The Commission has issued the enclosed Amendment No. 109 to Facility Operating License No. DPR-33 for the Browns Ferry Nuclear Plant, Unit 1. This amendment is in response to your application of July 31, 1984 (TVA BFNP TS 198).

The amendment changes the Technical Specifications to temporarily permit Train A of the Containment Air Dilution System to be considered operable with valve FCV-84-8B inoperable.

SAFETY EVALUATION BY THE OFFICE OF NUCLEAR REACTOR REGULATION

SUPPORTING AMENDMENT NO. 109 TO FACILITY OPERATING LICENSE NO. DPR-33

Containment Atmosphere Dilution System

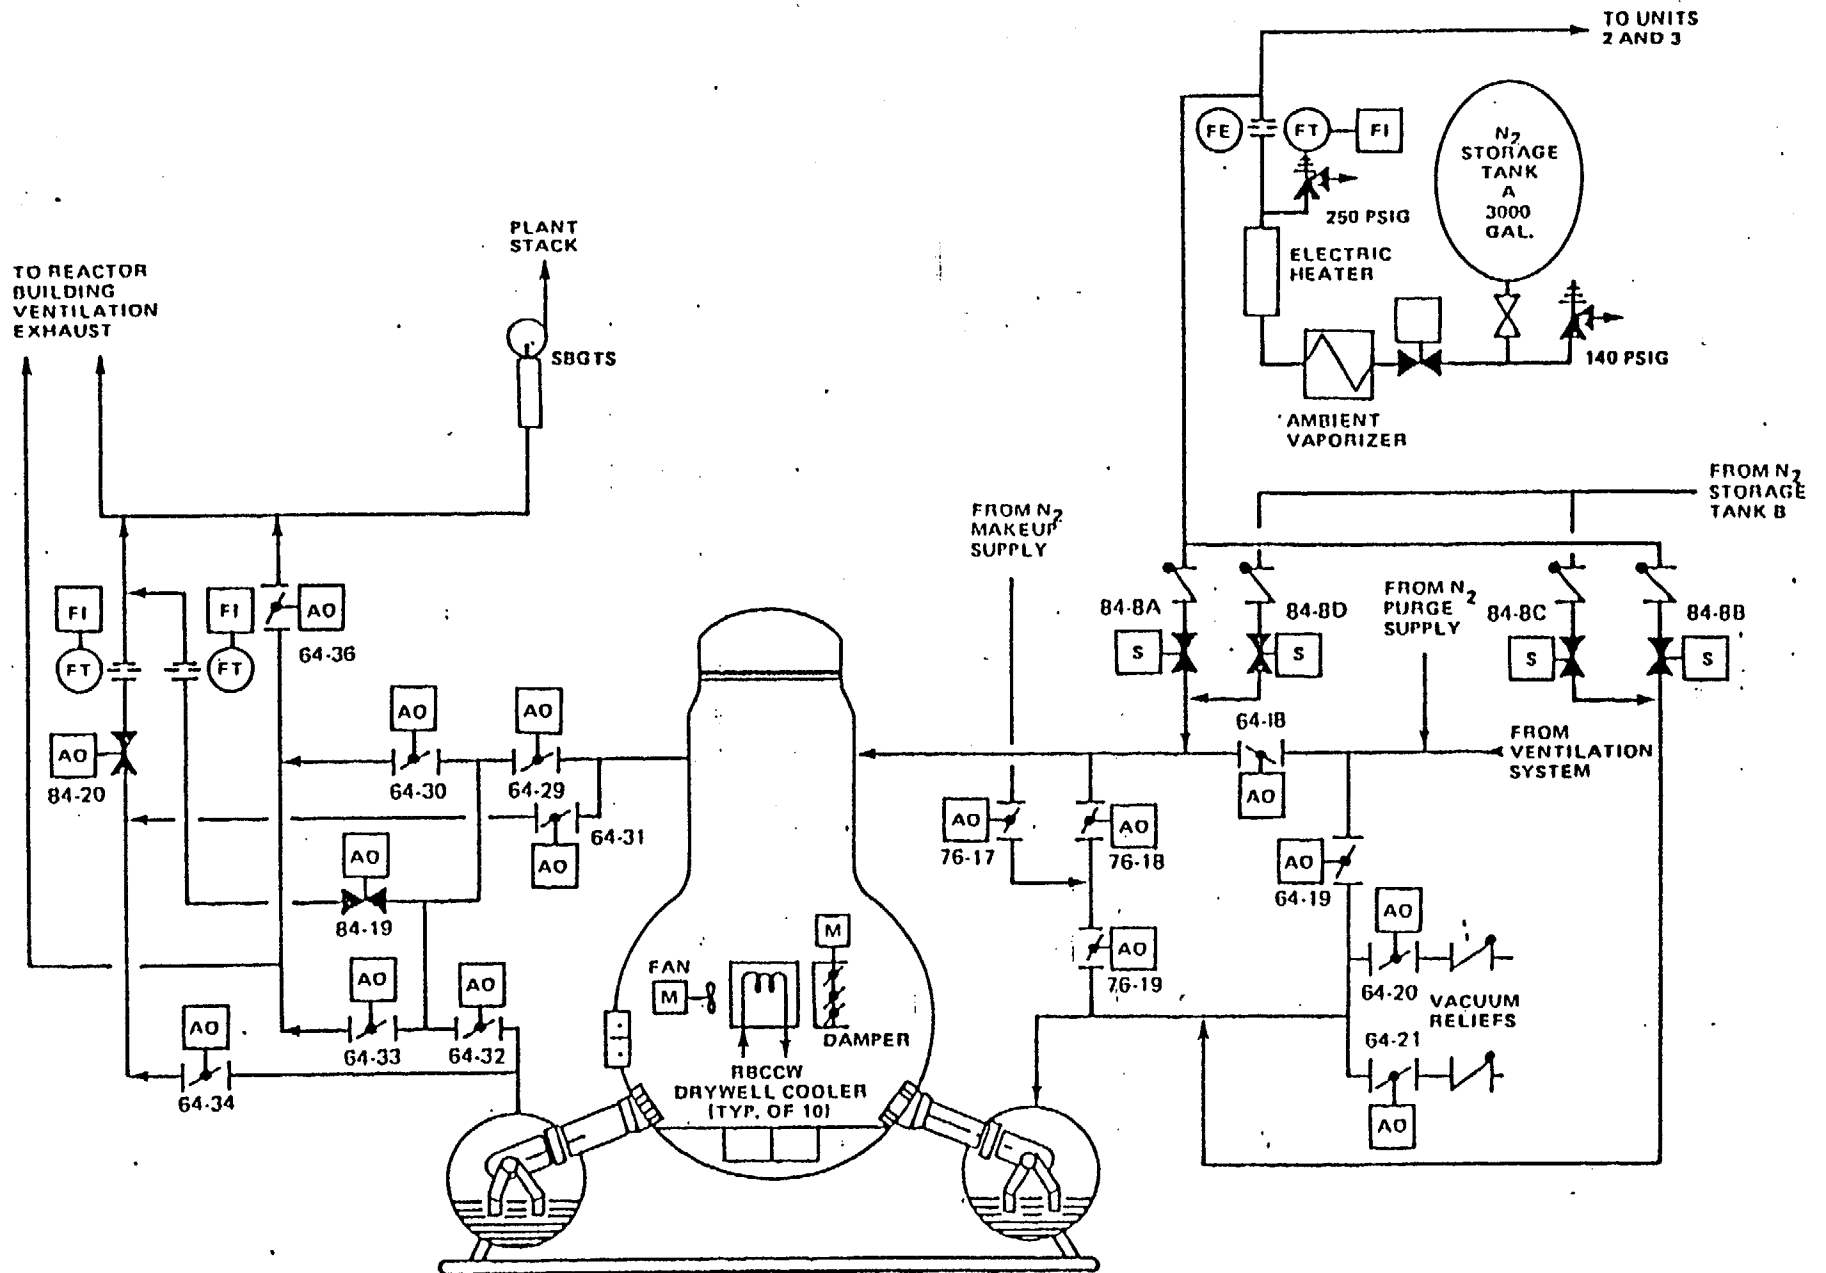
Valve FCV-84-8B (CAD supply to the torus; System A, see attached figure) was declared inoperable on July 17, 1984. Upon investigation, it was found that the valve could not be repaired without breaking primary containment. This would require the unit to be brought to a cold shutdown before repairs could be made.

1. The failure of valve FCV-84-8B, by itself, does not prevent train A from meeting its design objective (maintaining an inerted containment post-LOCA). An additional single failure is necessary to disable the system.

2. Train A, with the failure, has only one inlet to the containment which is to the drywell. The normal wetwell inlet has been isolated due to the valve failure. However, communication between the drywell and wetwell still exists via the downcomer-vent system. This pathway will allow nitrogen addition to both containment volumes. As a result, flexibility of operation is reduced but not the ability to meet the design objective.

6. System A may be considered operable with FCV 84-8B inoperable provided that all active components in System B and all other active components in System A are operable.

2. When FCV 84-8B is inoperable, each solenoid operated air/nitrogen valve of System B shall be cycled through at least one complete cycle of full travel and each manual valve in the flow path of System B shall be verified open at least once per week.
